# Access Compliance Report

## Public Rights-of-Way

Intersection ID: 49183	Main Street: ST_JOHN_LN	Cross Street: ST_STEPHEN_LN	Location: NW
ADA ID: 984E4290CA8E	Ramp Type: ParaDiag	Initial Pass/Fail: Fail	Overall Compliance: No
Codes/Mitigation Info/Possible Solution			Severity Score: 10
			Field Measurements/Component Compliance

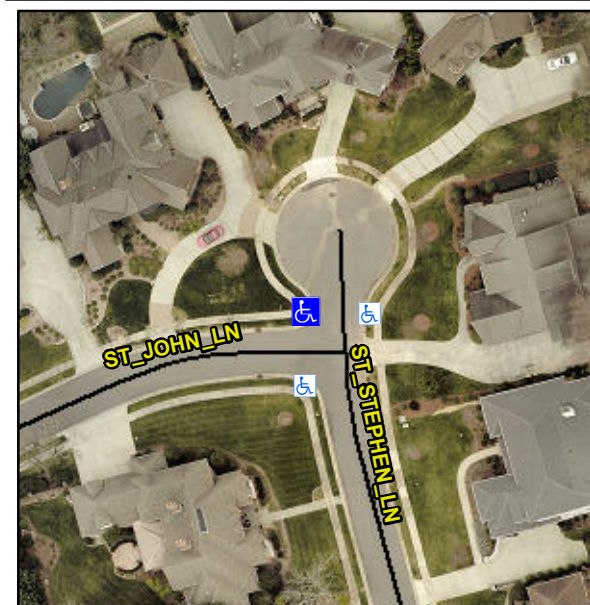
**LT RP < 5%**

**R304.5.1, R304.5.3**

**Remove & Replace Curb Ramp With Two New Directional Ramps or Equivalent.**
